**BS 5837:2005 Arboricultural Impact Assessment and Tree Protection Scheme
for a Proposed Replacement Garage at South Cottage, The Green, Harefield**

Client: Mr J Barrett
Architect: Michael Oakes, B.A.Hons
Author: Daniel Simpson, HND.For ND.Arb M.Arbor.A
Report Reference: TR.11.17.Rev_B
Date: 17th September 2012

Updated 30th July 2015

TREE PROTECTION PLAN

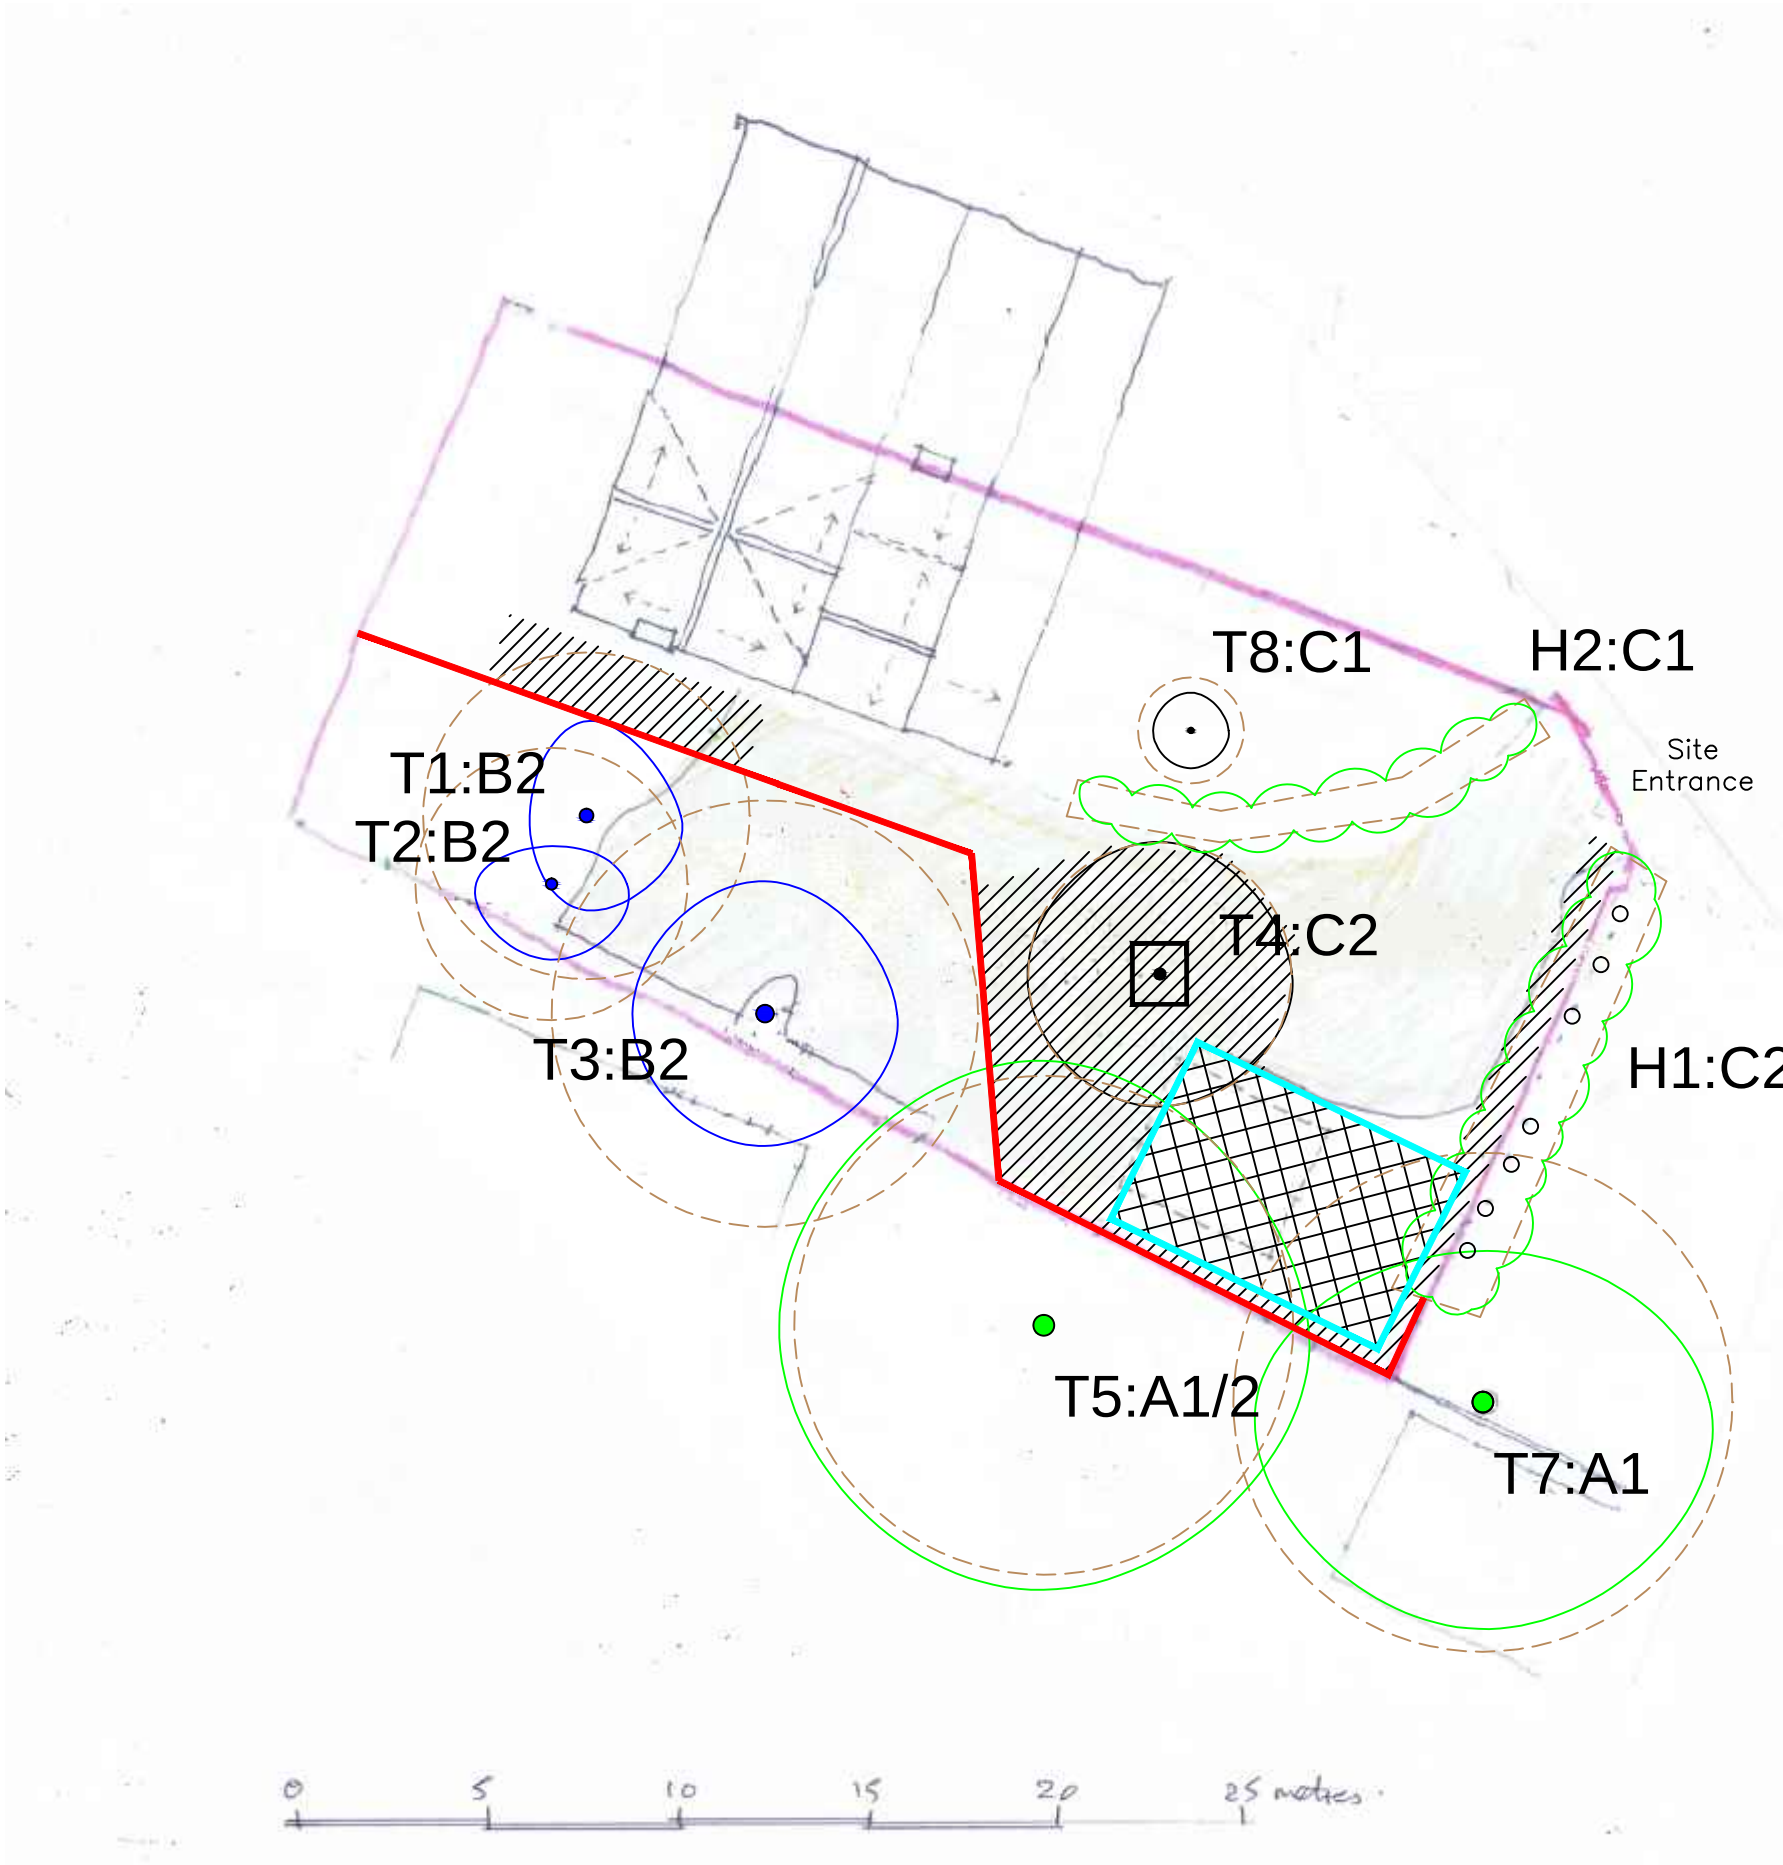
T4 and H2 no longer exist
